Modifications Required for Compliance

The Bevi Countertop 1.0 Needed the Following Modifications to Pass Radiated Emissions:

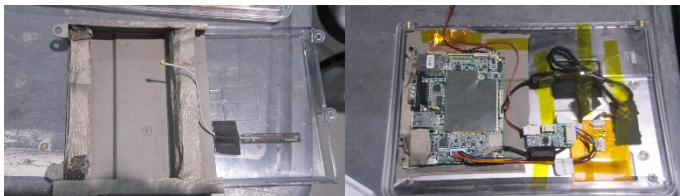
One Ferrite on the LVSD Cable under the Plastic Cover PN 0461178181

One Ferrite on the Touch Screen Cable PN: 0461178181
